STAFF REPORT

PLANNING & ZONING COMMISSION

1. PRELIMINARY DEVELOPMENT PLAN REVIEW

2. CERTIFICATE OF APPROPRIATENESS REVIEW

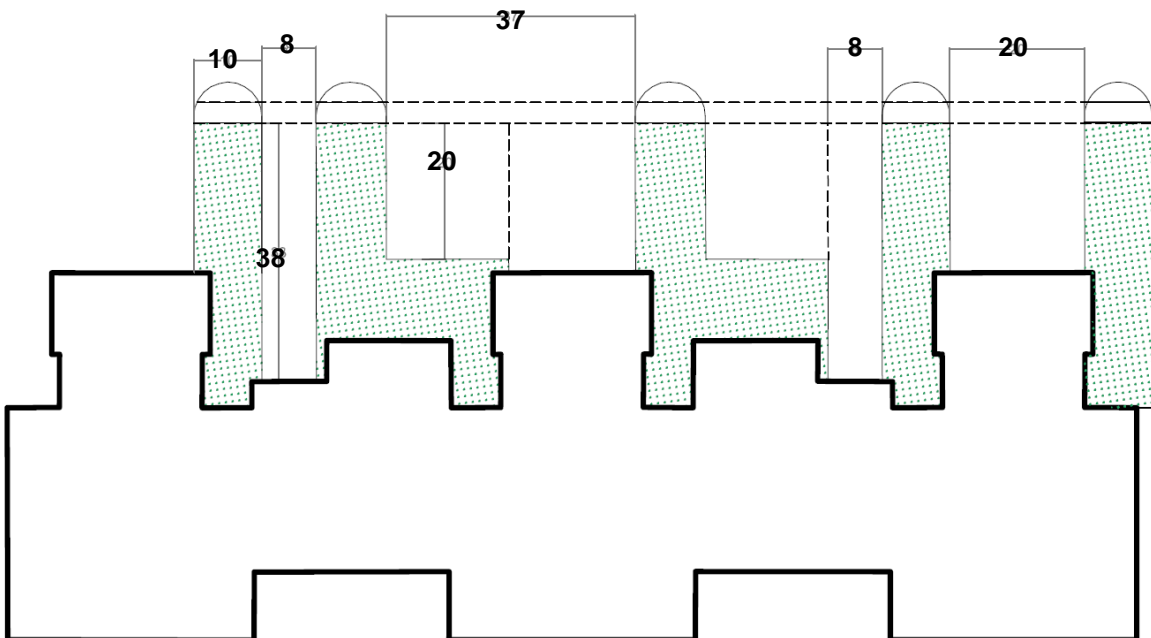
Staff just received the Traffic Study on Friday. We will update this report later. Staff does have an issue with the interior sidewalk plan related to the depth of parking driveways for the townhomes. The depth of parking areas are not deep enough. See the images on the next page. We need the applicant to pinch the rear of the townhome buildings a few feet closer together to create better parking situation where the parking does not interfere with sidewalks.

Signage and Graphics (PAG, P. 274)

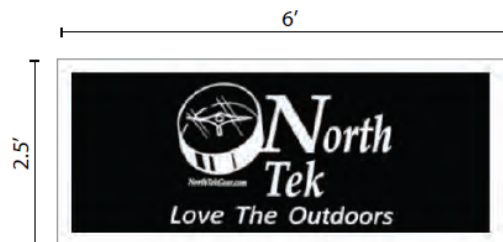
- The applicant provided a signage design that meets all of the PAG except that the size of the larger sign is too big and both signs are aluminum.
 - Overall size should not exceed 12 square feet in the Historic District.
 - The proposed sign is 24 square feet.
 - Wood is the preferred material for signs.
 - Staff defers to the Commission for their opinion.

Doors (PAG, P. 317)

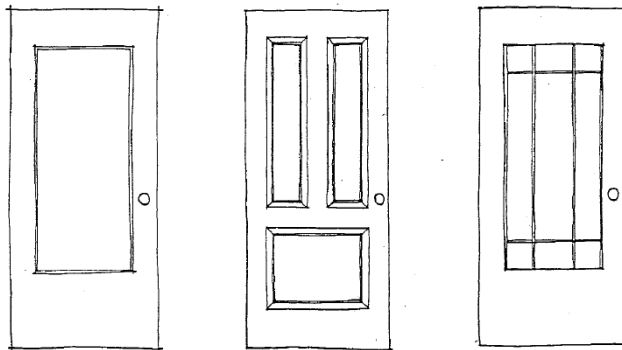
- The applicant's doors are in line with some of PAG recommendations.
 - Although wood doors are preferred, steel doors may be appropriate for replacement or new construction.
 - Staff defers to the Architectural Advisor for an opinion on the details of the door.
 - The PAG does not have guidelines regarding garage doors.
 - Staff defers to the Architectural Advisor for an opinion on the garage doors.
